September 16, 2019
BOARD OF COUNTY COMMISSIONERS
ORANGE COUNTY, FLORIDA
Y20-703-RC / ADDENDUM NO. 3
CONSTRUCTION OF ORANGE COUNTY FIRE STATION #87

This addendum is hereby incorporated into the bid documents of the project referenced above. The following items are clarifications, corrections, additions, deletions and/or revisions to, and shall take precedence over, the original documents. Underlining indicates additions, deletions are indicated by ~~strikethrough~~.

6 MONUMENT SIGN - DUMPSTER WALL ELEVATION
 3/4" = 1'-0"

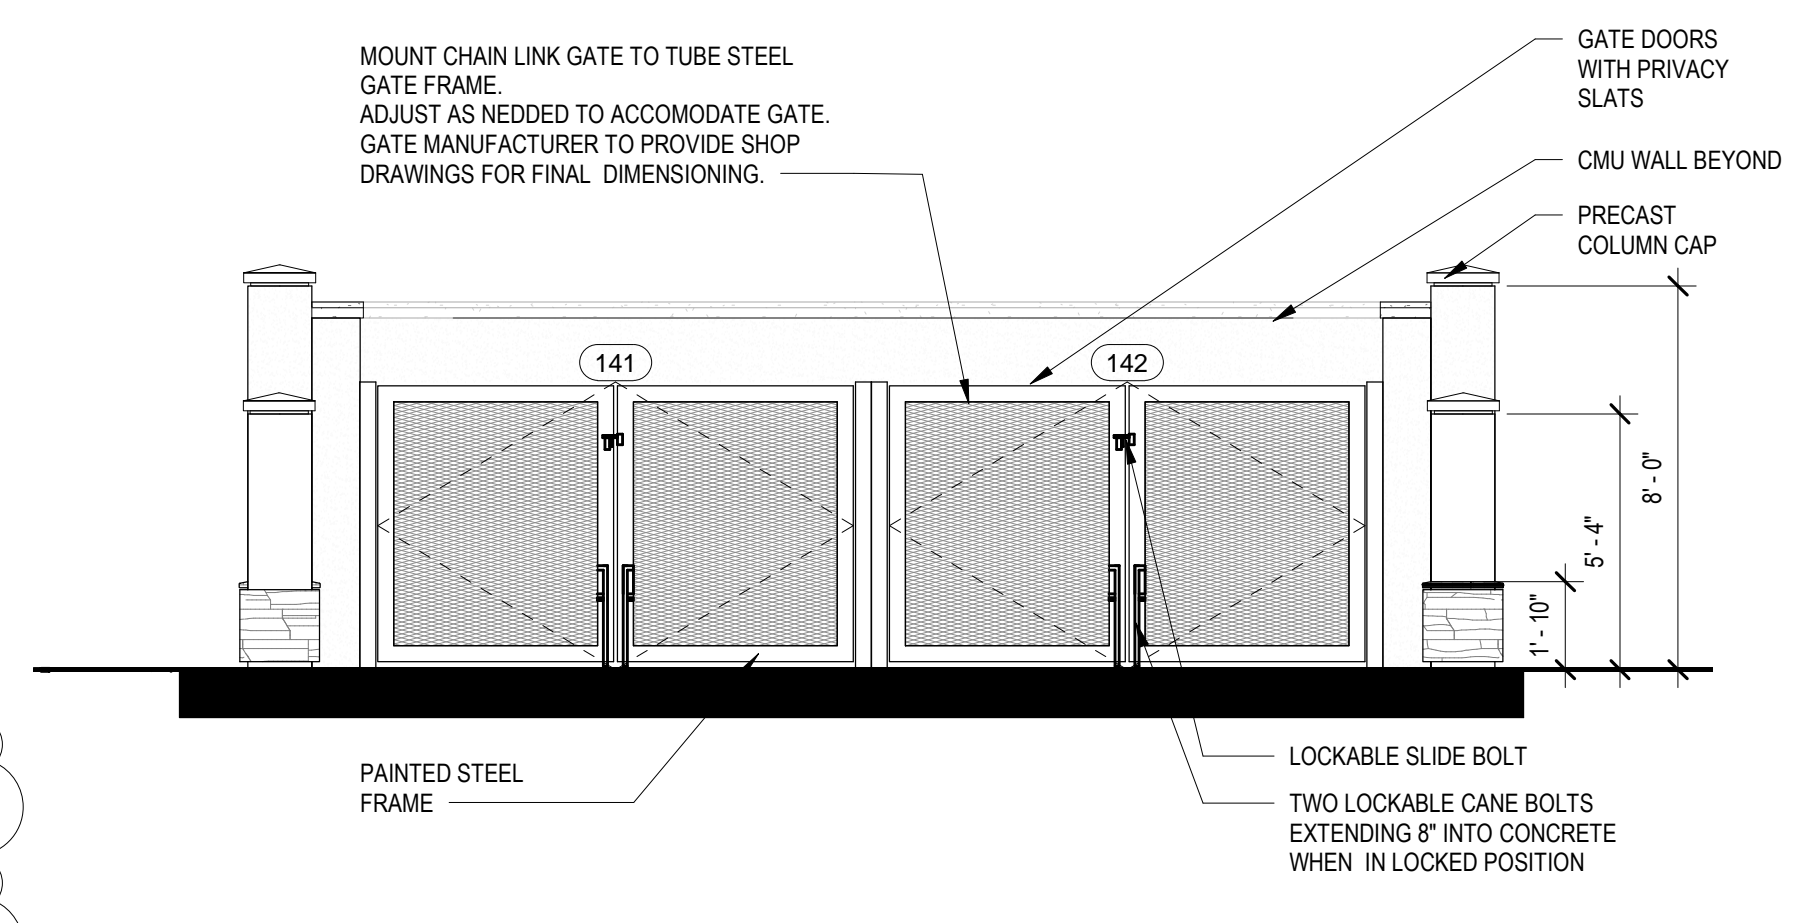
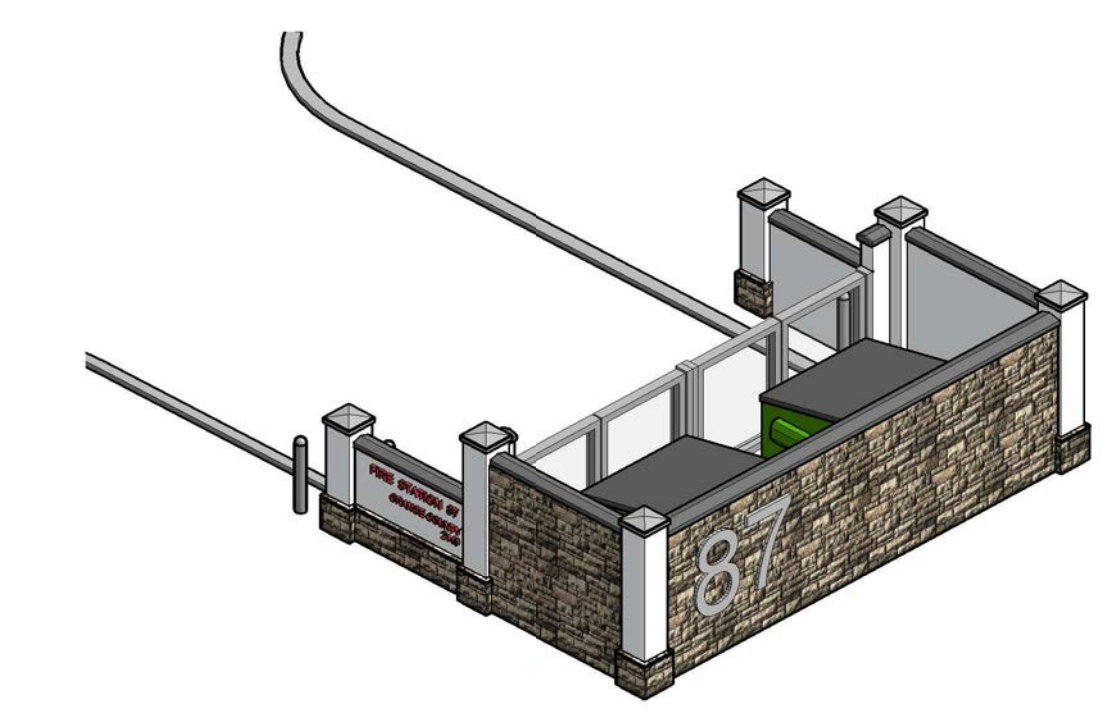
- C. Additions: Include new drawing sheet: OCFS Alerting System by USDD.
- D. Questions and Answers:
1. **Question:** Sheet A-010 Monumental Wall Elevation: are these 5" and 4" tall letters and a 16" plaque? If yes, what are the components applies to? Or are they integral to the stucco? How many?

17. **Question:** Monument wall signs confirm that the North elevation has FIRE STATION 87 ORANGE COUNTY 12345 + LOGO

18. **Question:** West elevation does NOT include the ORANGE COUNTY 12345 (only the FIRE STATION 87 + LOGO as shown.

Answer: Yes, 5" and 4" Letters and a 16" digitally printed logo applied to recessed acrylic. Sheet A-010 revised for additional detail.
 2. **Question:** Dumpster Wall Elevation: are these addition cast metal letters and a plaque? See above. How many?

Answer: Sheet A-010 revised for additional clarity.
 3. **Question:** Sheet ID-500 42" Diameter Cast Aluminum Custom Logo: Anodized, Giclee Print? Or Custom Painted full color logo? Pin mount (Manufacturer: Gemini).

Answer: Detail 6/A-010 revised for more clarity.

Answer: Dumpster monumental sign to be as shown in detail 6/A-010. Sheet A-010 revised.

• sheet title
**EXTERIOR
ELEVATIONS**

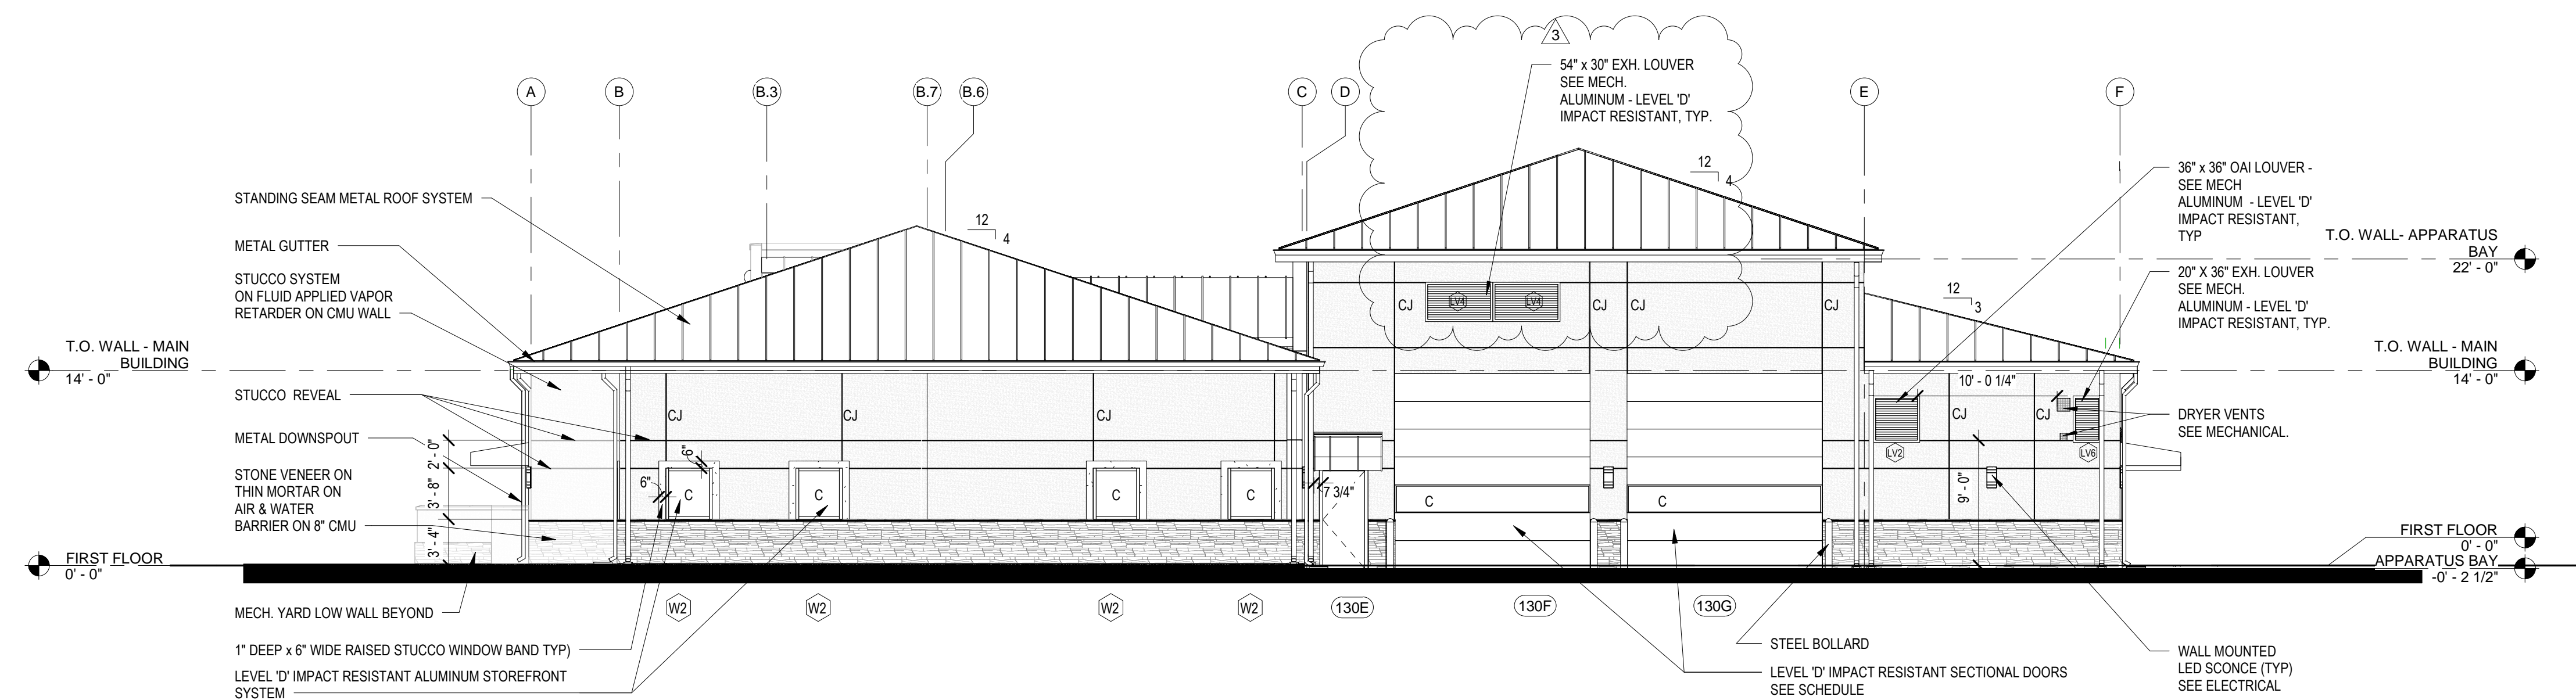
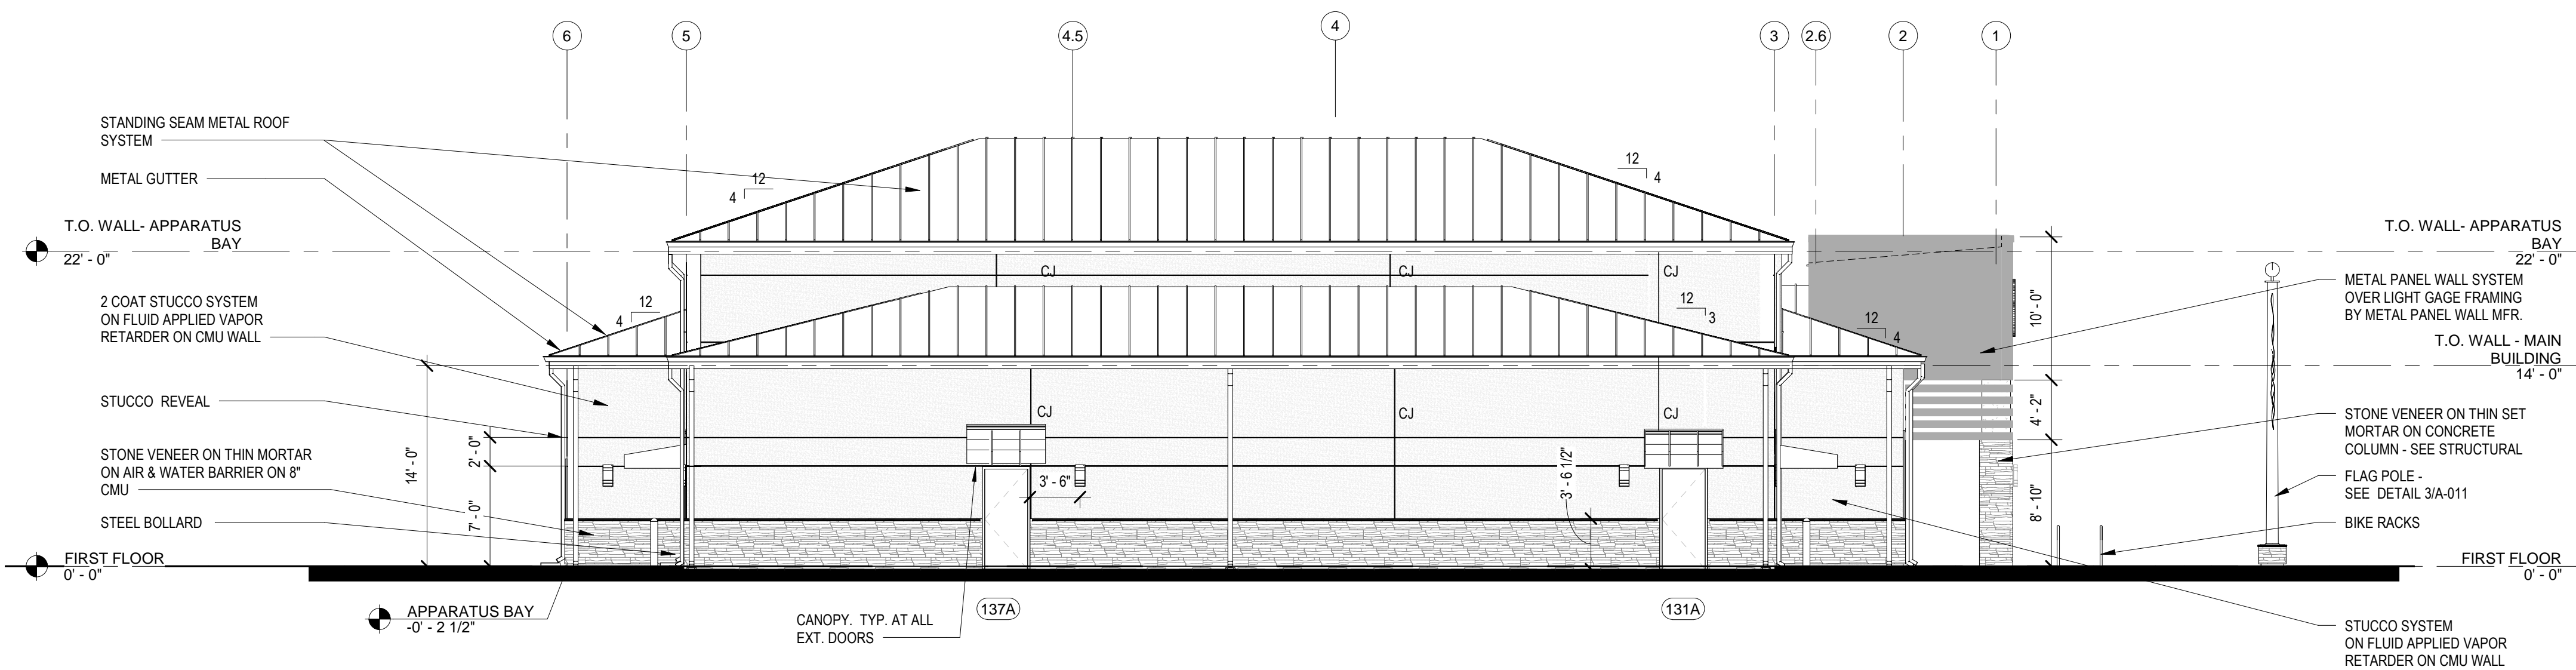
14. **Question:** The OH door specs are almost unusable as there are so many contradictions in material operation and not to mention even the basis of design manufacturer can't meet the level D impact resistance.

Answer: Spec section 083613-Sectional Doors revised and re-issued. Sheets A-202, A-312 & A-501 revised and re-issued to accommodate sectional door operator size.
